Change of material, V-Lock cord retaining feature as standard.

Product Change Notification					PCN GSP2 Appliance Inlet		
owner	creation date	release date	released by	change order no	rev	page	0118.2289
import	2015-12-05	2016-01-04	hotzar	2008799	A	1 of 2

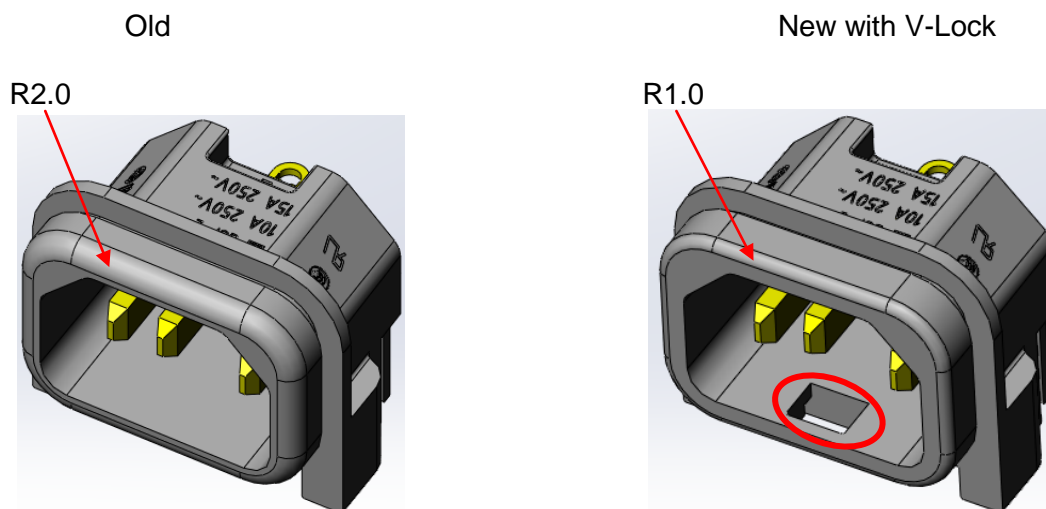
- Material change from PA6 to PA66/6 to pass the enhanced requirements of glow wire test acc. to IEC 60695-2-12 and -13
- V-Lock feature integrated as standard (not an option anymore)
- Radius on the front frame reduced from 2.0 to 1.0 mm

Form: Yes Socket has notch for V-Lock cord retaining and Radius on the front frame reduced from 2.0 to 1.0 mm
 Fit: No There are no dimensional changes
 Function: Yes V-Lock feature is standard (not an option anymore)
 Production Site: No There is no change of the production site
 Product Label: No No label change
